Subject: Additional Information regarding Commonwealth Edison Company's
Response to Questions Regarding the Increase in the
Interim Plugging Criteria for
Byron Unit 1 and Braidwood Unit 1
NRC Docket Numbers:50-454 and 50-456

In the reference letter, the Nuclear Regulatory Commission transmitted to the Commonwealth Edison Company (ComEd) a request for additional information (RAI) regarding the technical bases supporting the pending license amendments, which involves an increase in the interim plugging criteria for steam generator tubes at Byron Unit 1 and Braidwood Unit 1. Attached is ComEd's response to this RAI (questions 49 to 54).

REQUEST FOR ADDITIONAL INFORMATION
REGARDING THE PROPOSED REVISIONS TO THE TECHNICAL SPECIFICATIONS
RELATED TO THE STEAM GENERATOR TUBE VOLTAGE-BASED REPAIR CRITERIA
BYRON, UNIT 1, AND BRAIDWOOD, UNIT 1
DOCKET NOS. STN 50-454 AND STN 40-456

Figure 54-1: Axial Rupture Force vs. Bobbin Amplitude
 Data Adjusted to 3/4" x 0.043" SG Alloy 600 MA Tubes, $S_r = 75$ ksi

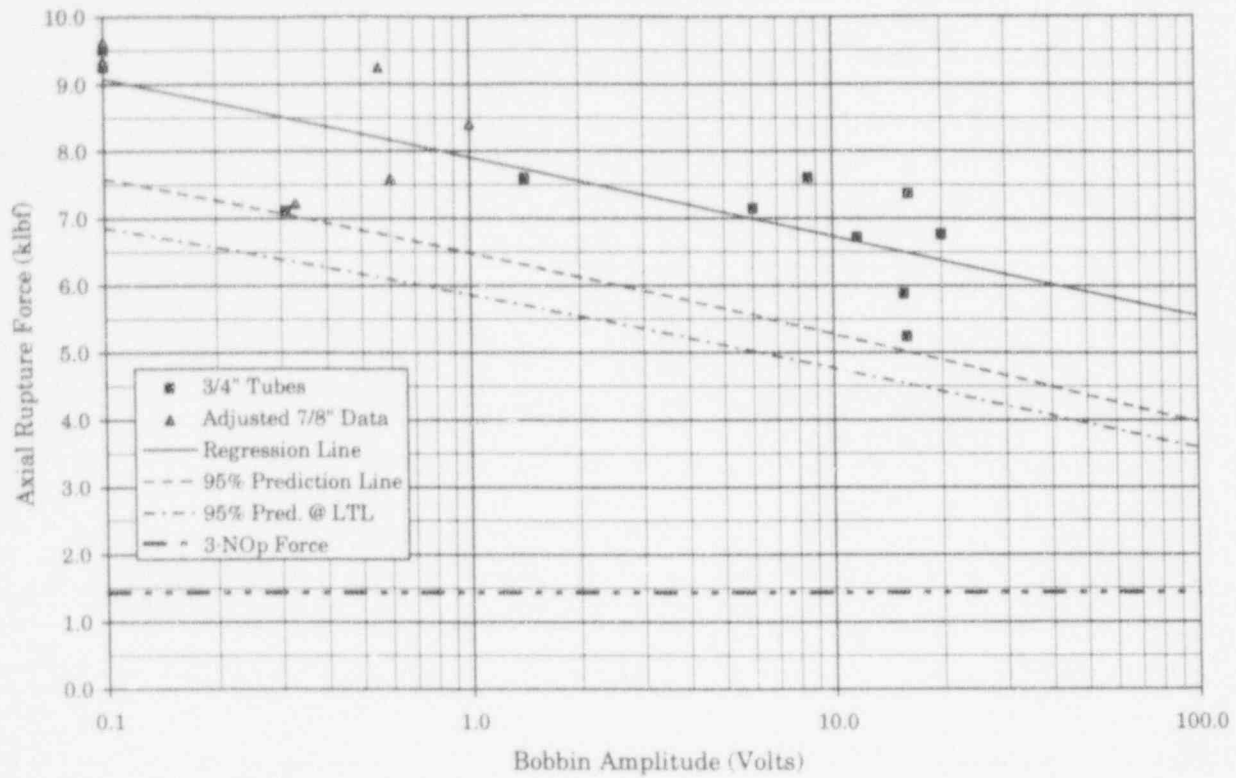
Provide a plot of the axial force required to fail a SG tube versus the bobbin voltage for those SG tube specimens which were tensile tested. Provide a discussion of the material properties adjustments made to the data, if any. Discuss how the lower tolerance limit material properties curve was developed in Figure 41-1 given that both 3/4-inch and 7/8-inch data are used. The staff notes that the residual SG tube cross-sectional area may vary with the axial elevation of the degradation. For the correlation in Figure 41-1, discuss how the appropriate residual cross-sectional area was determined (i.e., the location where the circumferential severance is postulated to occur).

The results of the regression analysis are provided in Table 54-3 and illustrated on Figure 54-1. In summary, the axial rupture force in thousands of pounds, klbs, can be reliably predicted from the bobbin amplitude as,

$$F_r = 7.905 - 1.173 \log(V). \quad (3)$$

The standard error of the rupture force predicted by the regression equation is 0.788 klbs. The standard error of the slope coefficient is 0.219 and the p -value for the slope coefficient is 8.0×10^{-5} . Since this is less than the criterion value of 0.05, i.e., 5%, the use of the regression equation is considered to be justified.

Using the above equation, a 95% one-sided prediction bound for the rupture force as a function of bobbin amplitude was calculated. The resulting curve was also adjusted to represent 95/95 lower tolerance limit (LTL) material properties. Both of these curves are also depicted on Figure 54-1. It is apparent that the structural limit obtained from this analysis approach is in excess of 100 volts.
